Access Compliance Report Public Rights-of-Way (Curb Ramps)

Intersection ID: 45644 Main Street: W 5TH ST Cross Street: W_6TH_ST Location: Ε

Overall Compliance: No ADA ID: D2A5DD54F328 Ramp Type: BlendTrans1 Initial Pass/Fail: Pass **Severity Score:** 7.5

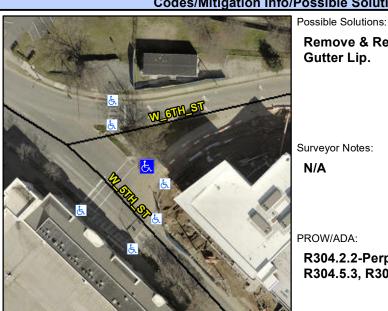
W 6TH ST Street 1 Name Stop Condition-Street 1 Signal Street 2 Name N/A Stop Condition-Street 2 N/A Remove & Replace Landing. Grind Gutter Lip.

PROW/ADA: R304.2.2-Perp, R304.3.2-Para, R304.5.3, R302.7.2
